TRUSS REPAIRS - BUILDING 403
LOWER RESERVATION
FORT MACARTHUR, CALIFORNIA

PREVIOUS TRUSS CORRECTIONS AND DETAILS

DRAWING NO. 68-62
SHEET 4 OF 4
SCALE: Noted
DATE: 28 Mar '68
P.R. NO. 1078

PREVIOUS TRUSS CORRECTIONS
RECREATION (BAR) ROOM AREA
No Scale
Above work accomplished in 1950

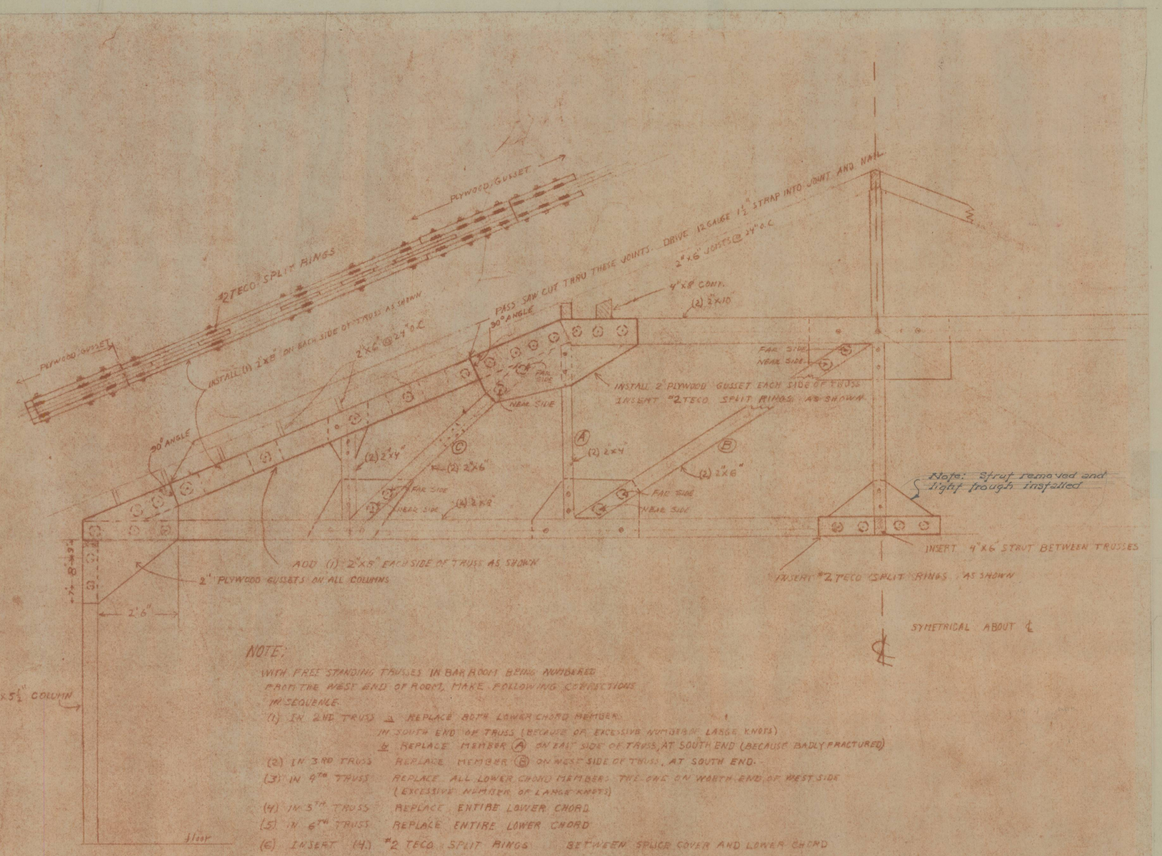
WITH FREE STANDING TRUSSES IN BAR ROOM BEING NUMBERED FROM THE WEST END OF ROOM, MAKE FOLLOWING CORRECTIONS IN SEQUENCE.

(1) IN 2ND TRUSS ⚠ REPLACE BOTH LOWER CHORD MEMBER IN SOUTH END OF TRUSS (REMOVE OF EXCESSIVE NUMBER OF LARGE KNOTS)
⚠ REPLACE MEMBER (A) ON EAST SIDE OF TRUSS, AT SOUTH END (BECAUSE BADLY FRACTURED)

(2) IN 3RD TRUSS REPLACE MEMBER (B) ON WEST SIDE OF TRUSS, AT SOUTH END.

(3) IN 4TH TRUSS REPLACE ALL LOWER CHORD MEMBERS THE ONE ON NORTH END OF WEST SIDE (EXCESSIVE NUMBER OF LARGE KNOTS)

(4) IN 5TH TRUSS REPLACE ENTIRE LOWER CHORD

(5) IN 6TH TRUSS REPLACE ENTIRE LOWER CHORD

(6) INSERT (4) #2 TECO SPLIT RINGS BETWEEN SPLICE COVER AND LOWER CHORD ON EACH SIDE OF TRUSS.

(7) REMOVE WEB MEMBERS (B) & (C). INSERT (1) 2 TECO SPLIT RINGS BETWEEN WEB MEMBER AND GUSSET ON EACH SIDE OF TRUSS, AT BOTTOM END OF WEB MEMBER (B) & (C) AND AT TOP OF MEMBER (B) & (C)

(8) INSTALL 2" PLYWOOD GUSSETS ON EACH SIDE OF EACH HEEL JOINT, INSERTING 2 TECO SPLIT RINGS AS SHOWN. USE 3" MALLEABLE IRON WASHERS UNDER HEADS AND NUTS OF ALL BOLTS

(9) INSTALL 2" PLYWOOD GUSSET AT EACH SIDE OF KNEE JOINTS AS SHOWN INSERTING 2 TECO SPLIT RINGS BETWEEN GUSSET AND UPPER CHORDS AND MEMBER (C)

(10) INSTALL (1) 2"x8" ON EACH SIDE OF TRUSS, BETWEEN HEEL AND KNEE JOINTS AS SHOWN

(11) DISTANCE FROM CENTER OF SPLIT RING TO END OF WOOD MEMBER SHALL BE 6" IN UPPER CHORD, AND 7" IN ALL OTHER MEMBERS.

PLAN
DETAIL 3 ⚠
Scale: 1" = 1'-0"

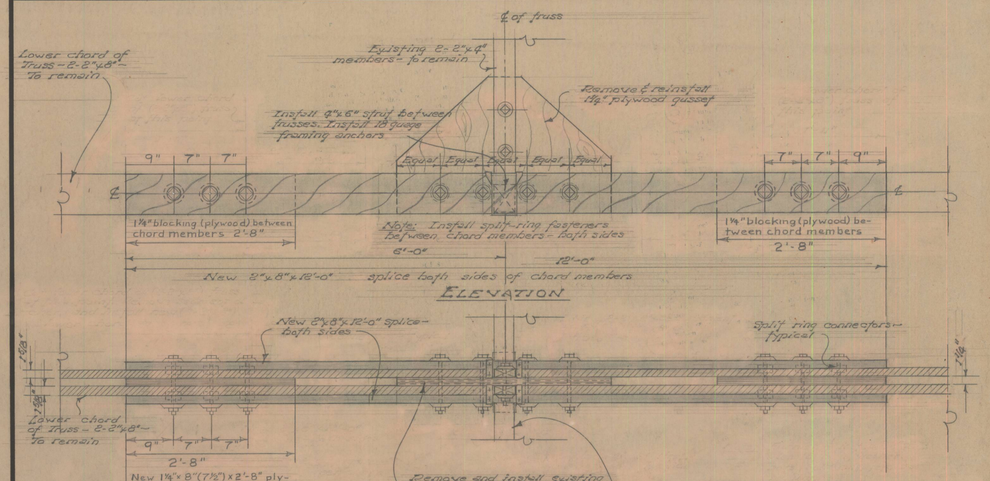
REVISION	DATE	DESCRIPTION	BY
⚠	25 Oct 68	Revised Detail 3, Omit Knee Brace	LJR

Note: All split rings shall be 4".
All washers shall be 4" O.G.
All bolts shall be ¾" dia with hex head & nut
